Syracuse City Planning Commission Meeting April 5, 2016

Regular Meeting Agenda

4. **Site Plan Approval**, Utah Onions, property located at 850 S 2000 W
 5. **Public Hearing, Site Plan Approval**, CVS Plaza, property located at 1974 W 1700 S

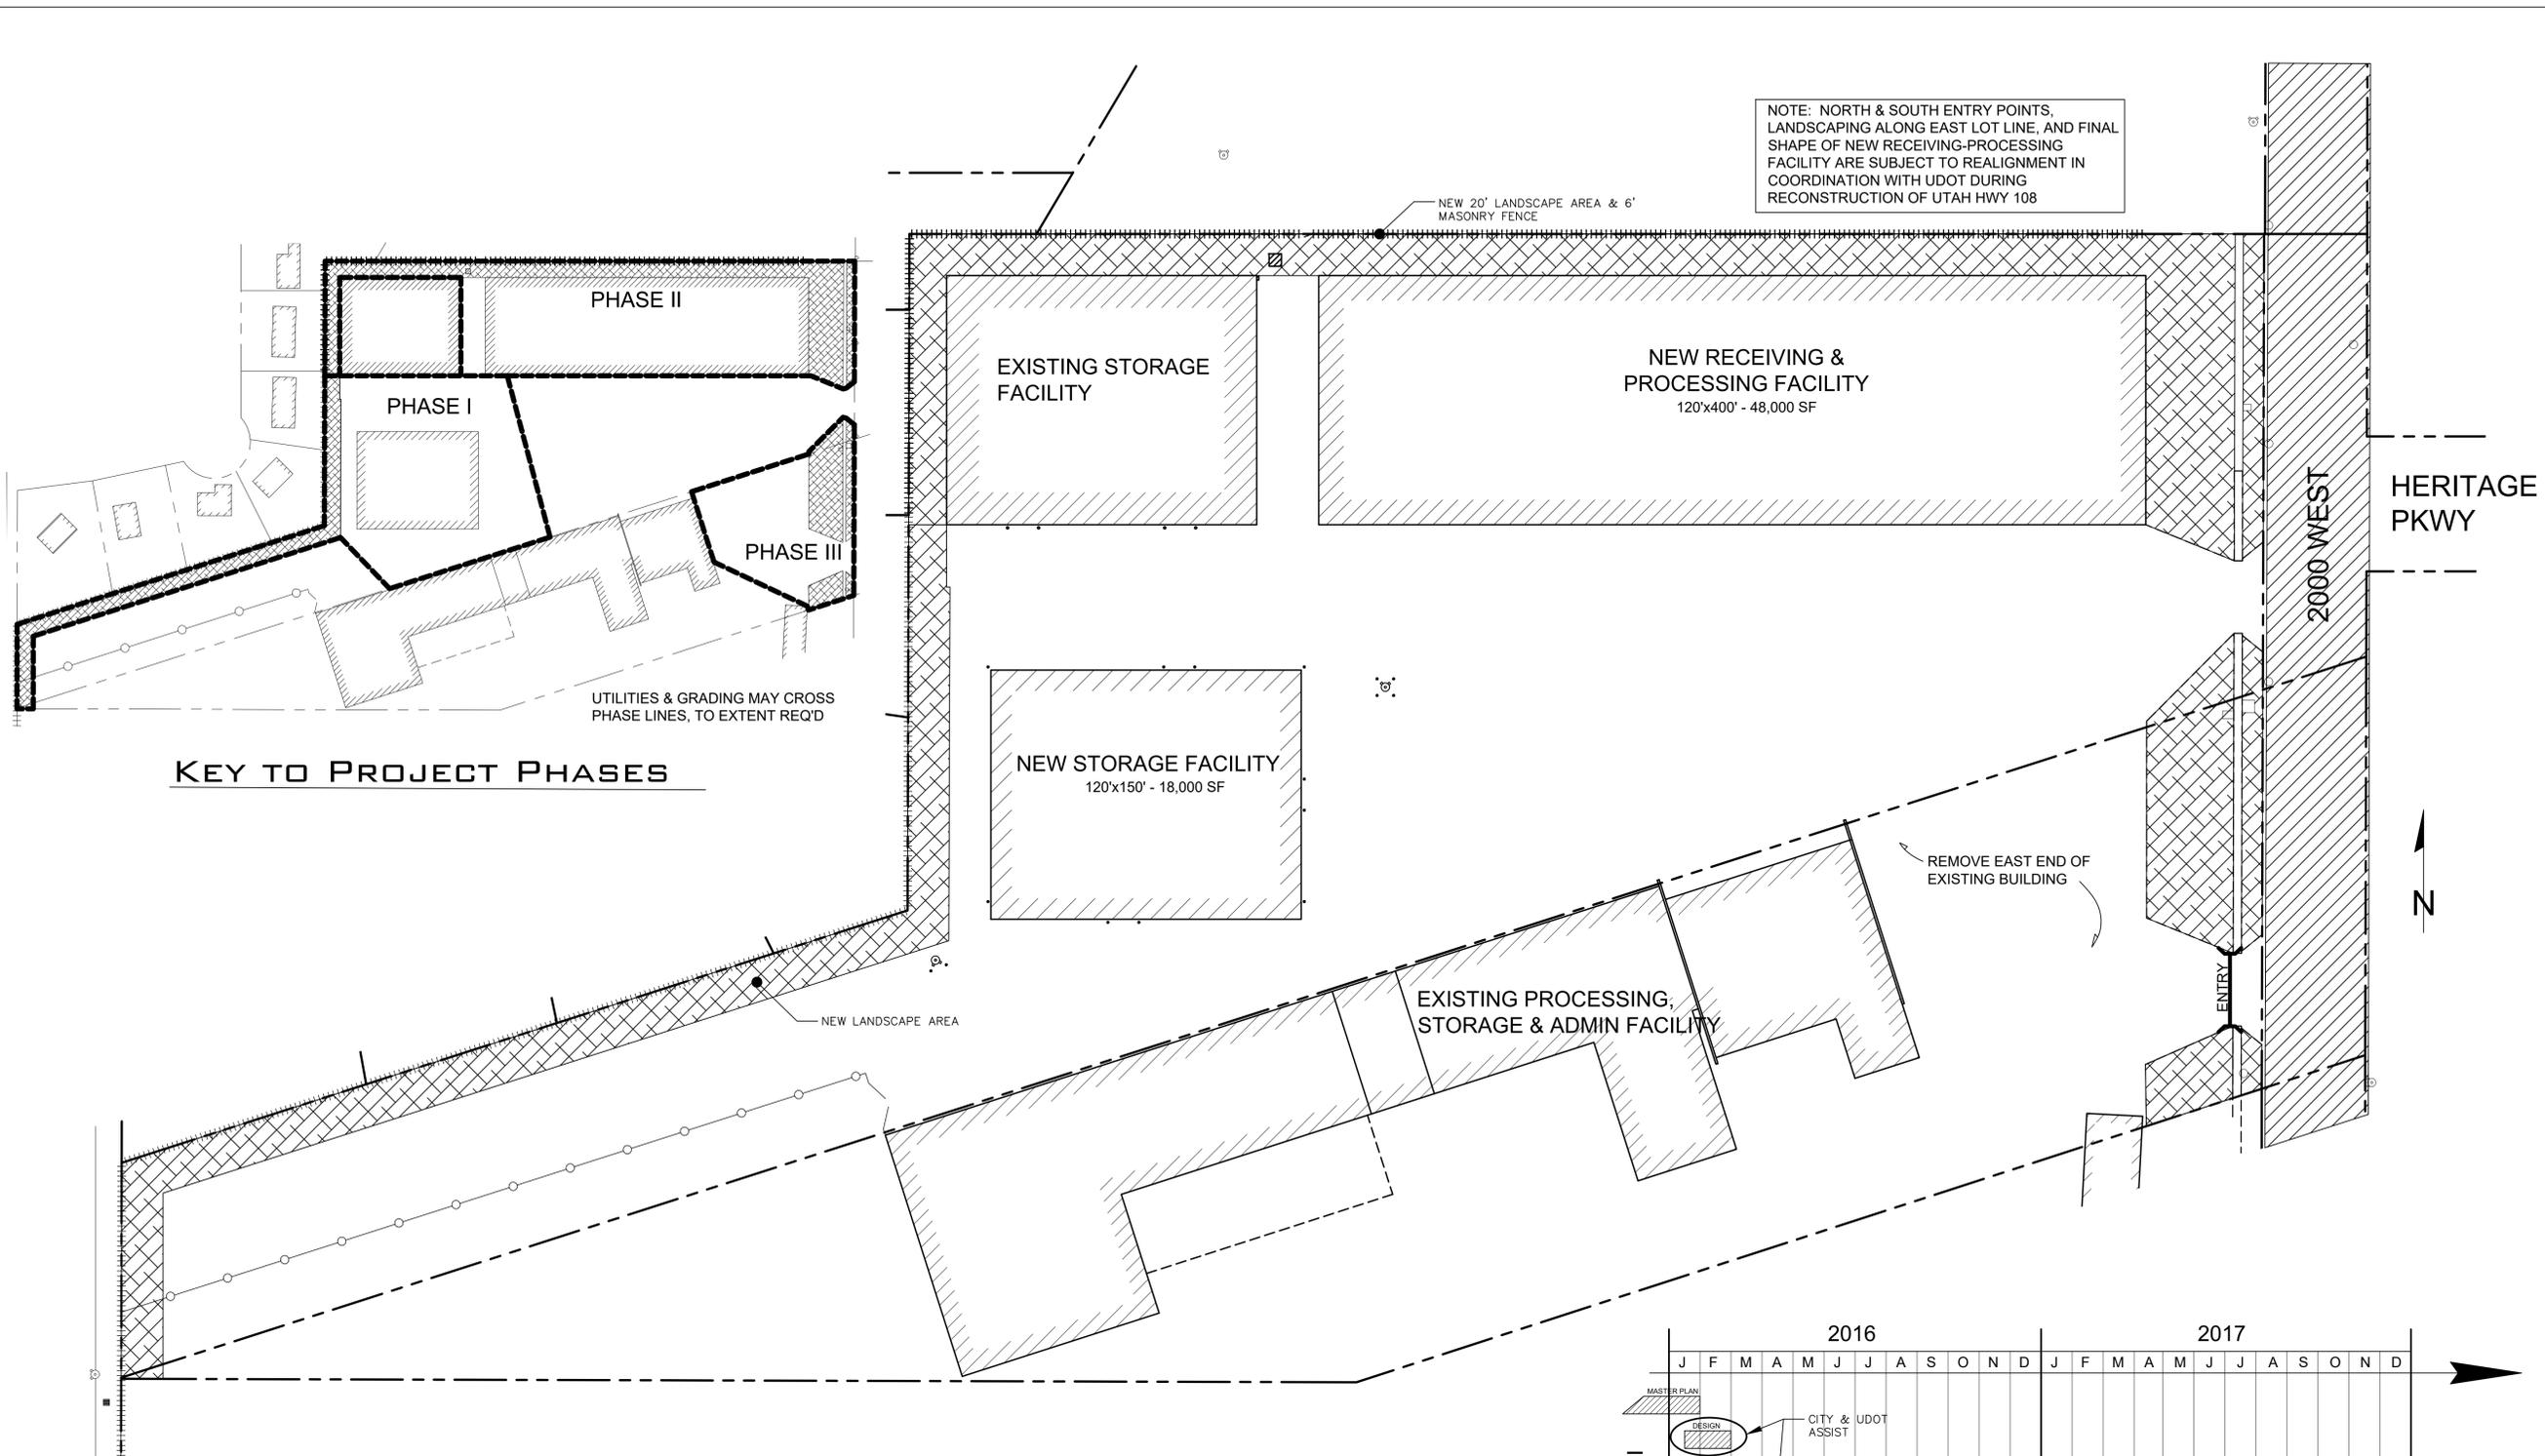
11. Building coverage numbers.
RESPONSE. Concur – see new table entitled “Total Utah Onions,” with coverage numbers through Phase III. Note that new table includes Tax I.D. 12-048-0137.
12. East elevation.
RESPONSE. Concur – see revised east elevation, Sheet A2, which provides all suggestions from Architectural Review Committee meeting, 29 February 2016.
13. Lighting locations.
RESPONSE. Concur – exterior light locations are shown on Elevations, Sheet A2. Sheet A2 also includes note requiring LED and “dark sky” lighting to avoid light pollution.

SHEET C4
 Utilities Plan

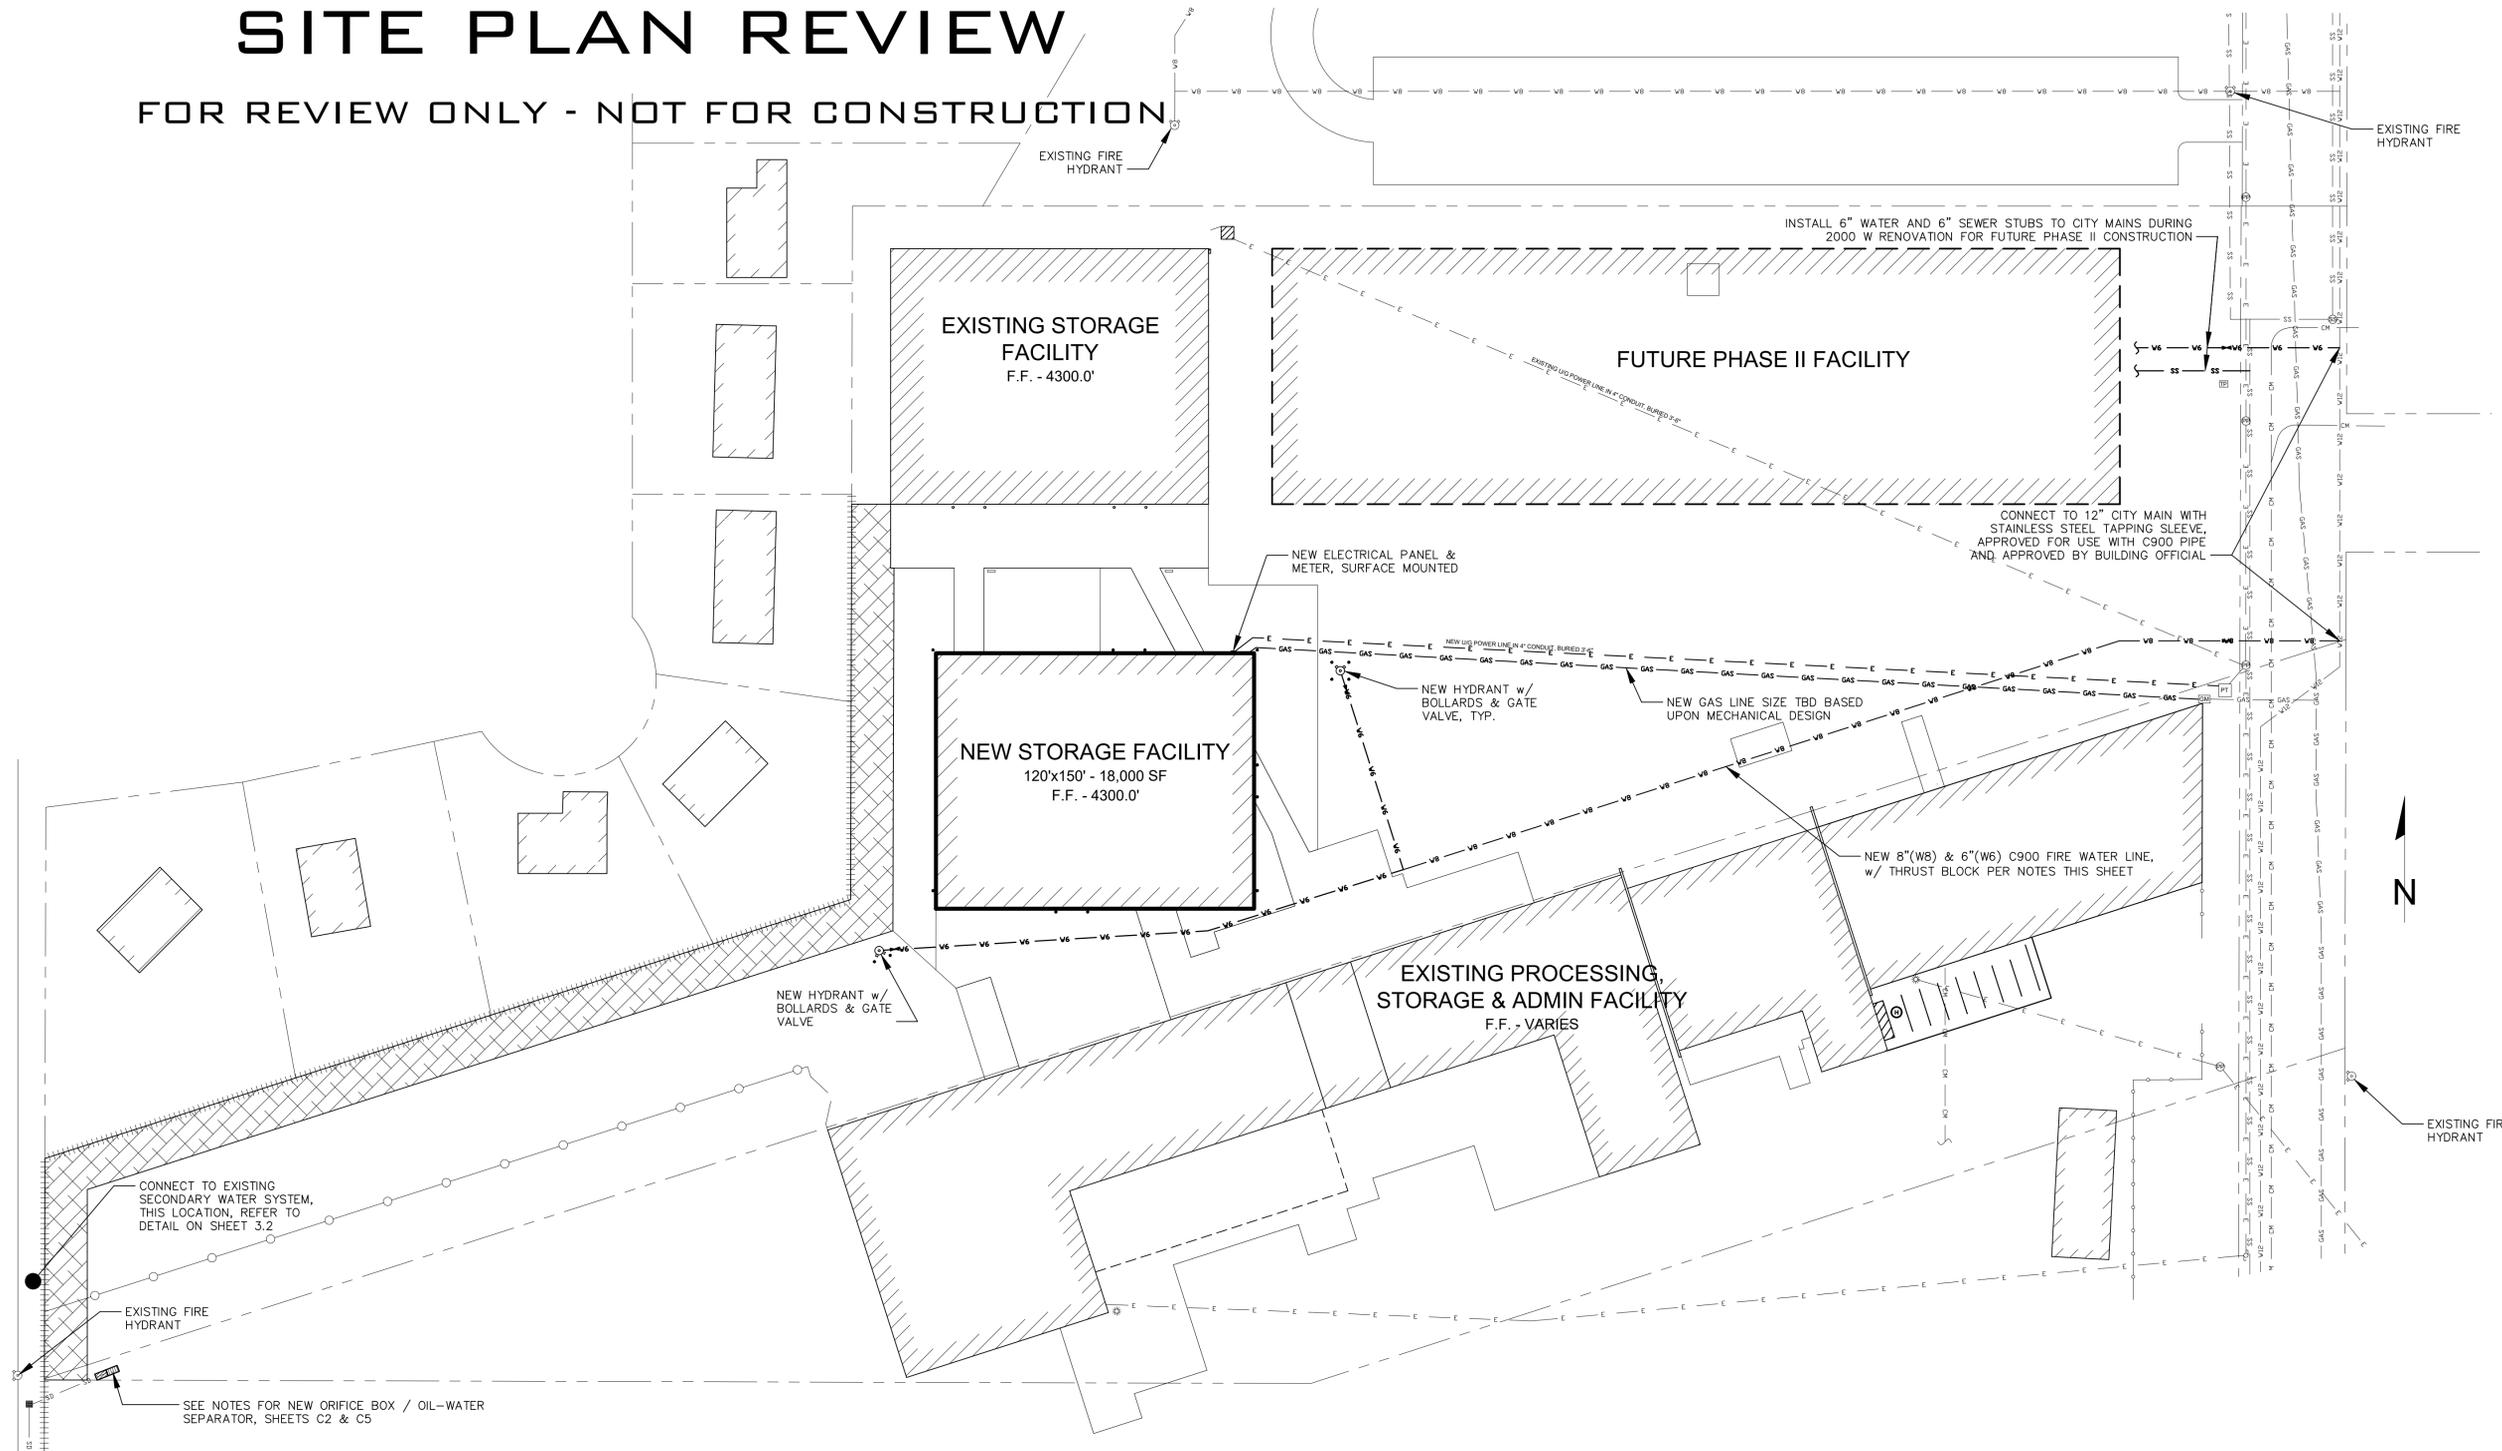
RESPONSE. Concur – see change in tapping sleeve material and supply line location, Sheet C4.

3. Oil-water Separator.
RESPONSE. Concur – refer to revised Drawing Sheets C3 & C4 for addition of oil and debris separation capability.
4. Detention basin maintenance agreement.

SHEET C5
 Grading & Drainage Plan

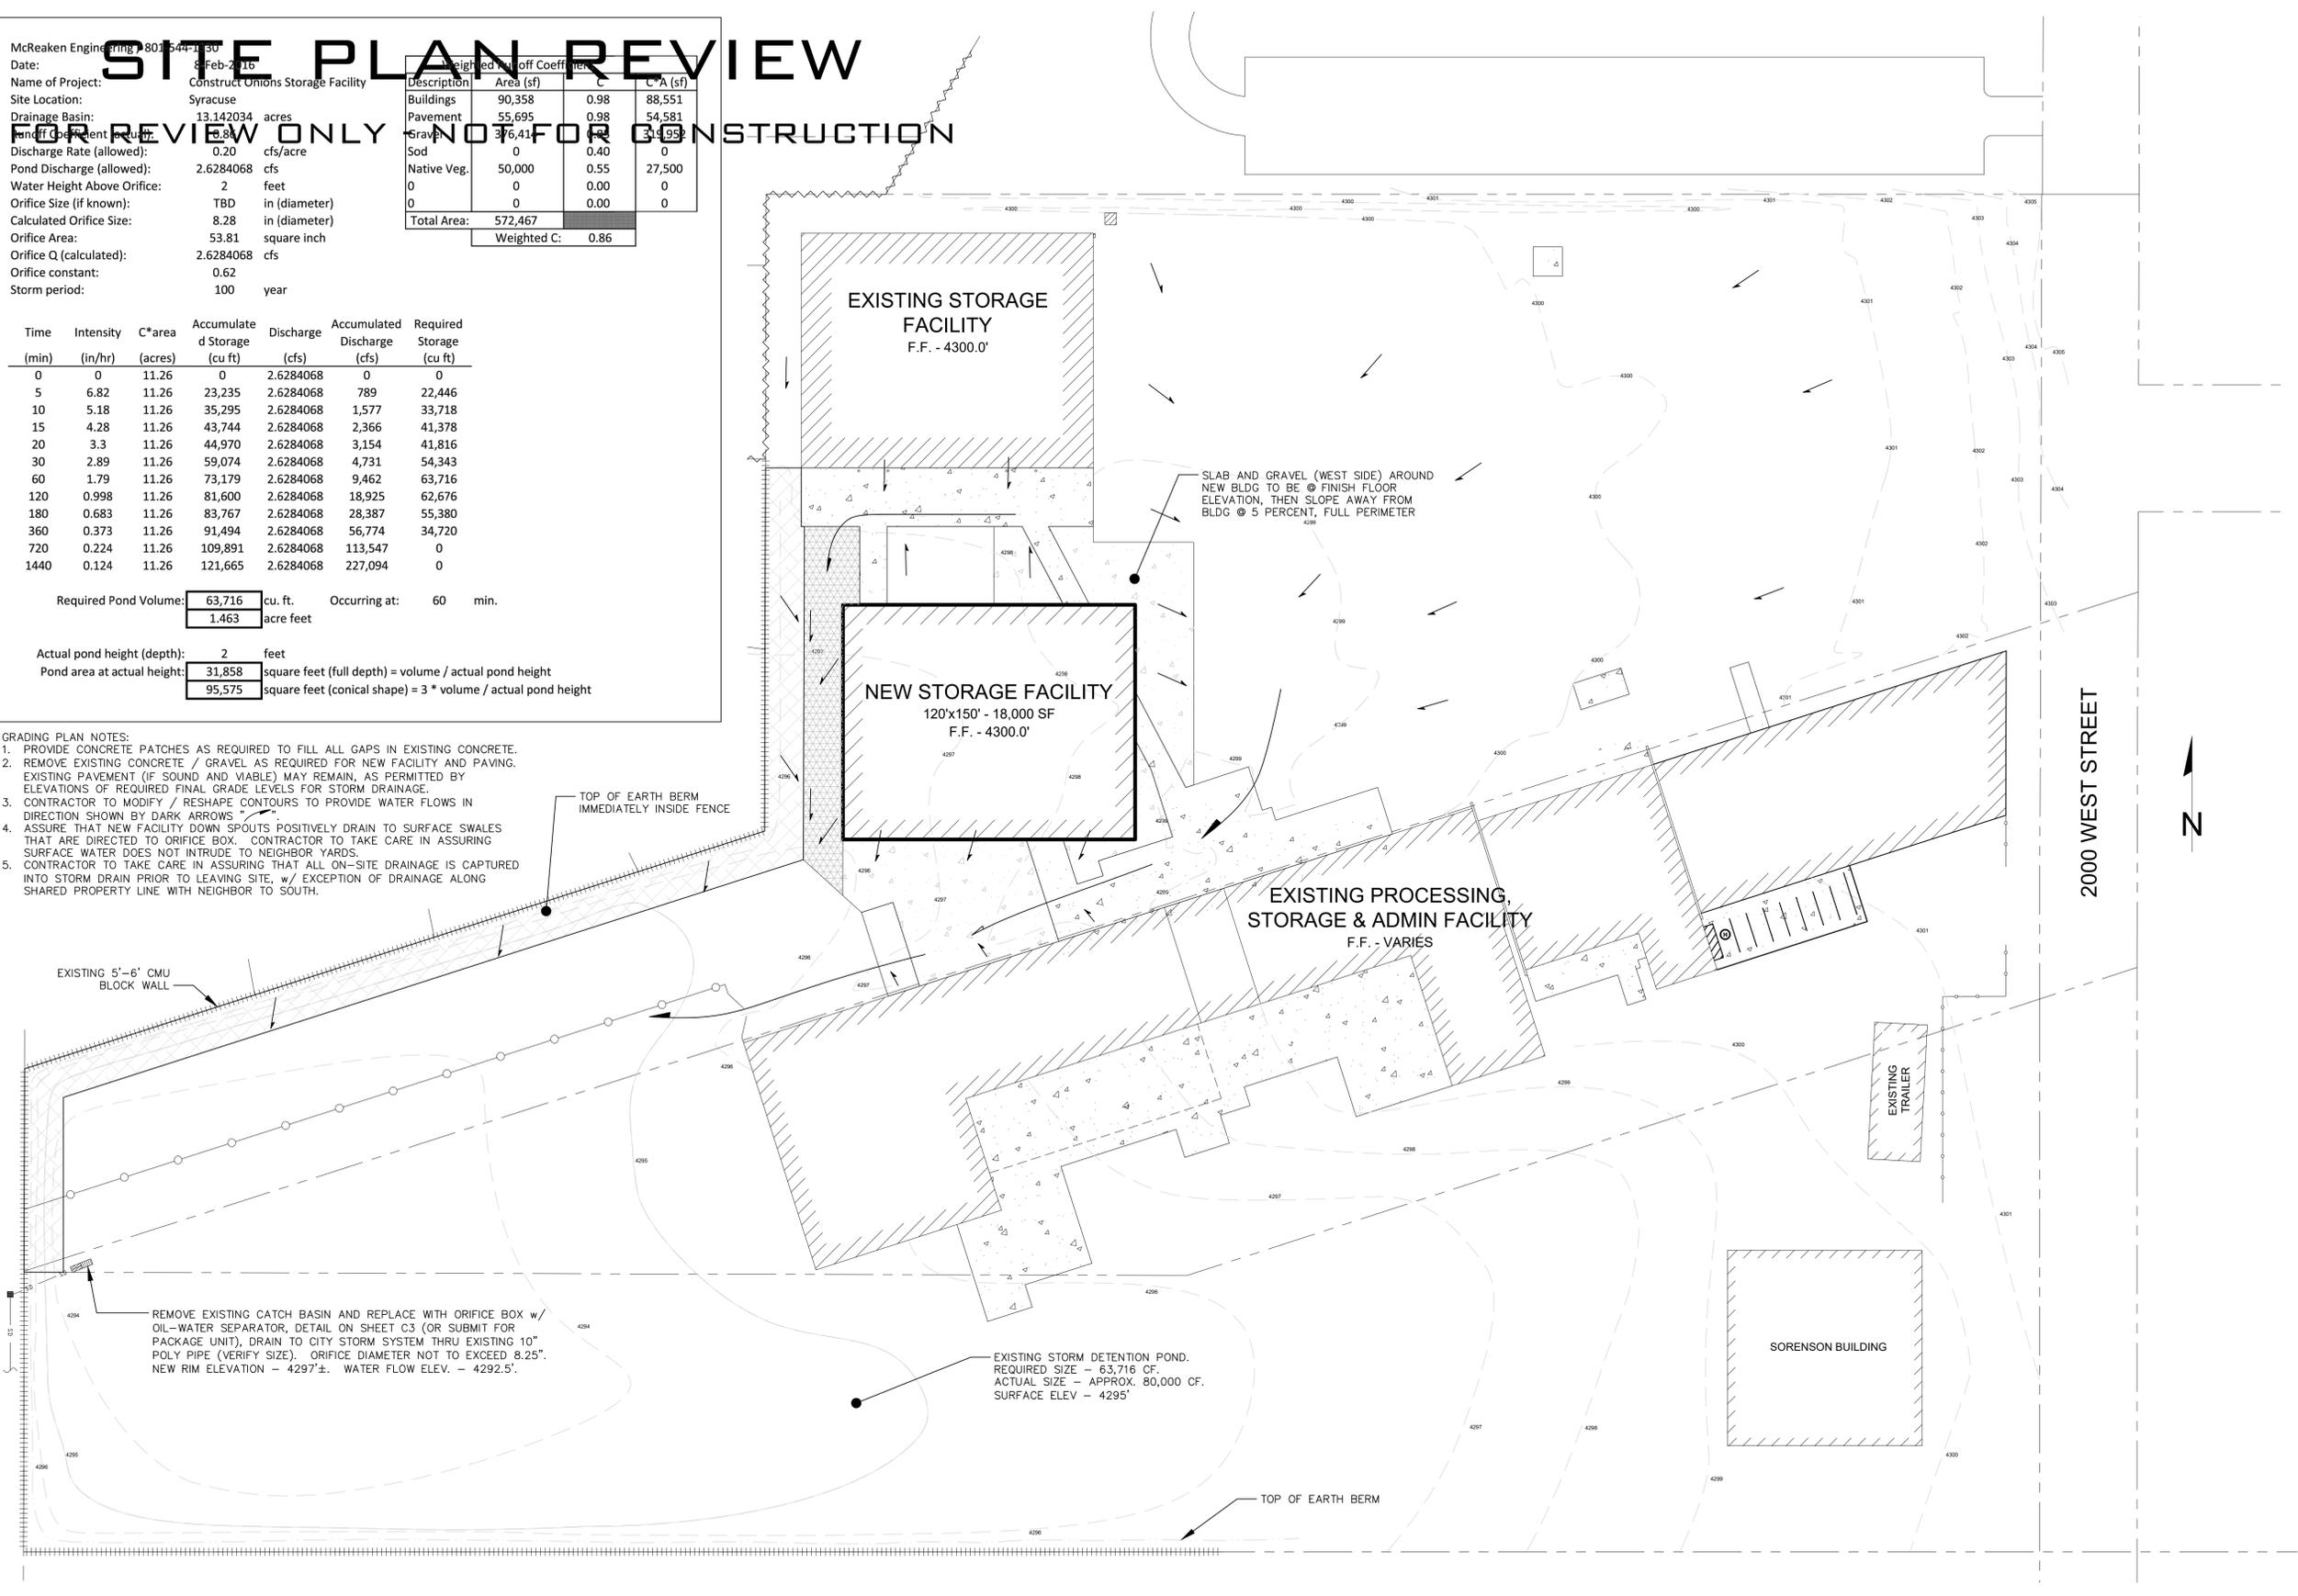
RESPONSE. Concur – see note added to Sheet C5.

RESPONSE. Concur – see revised orifice box / oil-water separator requirements, Sheet C2 & C5.
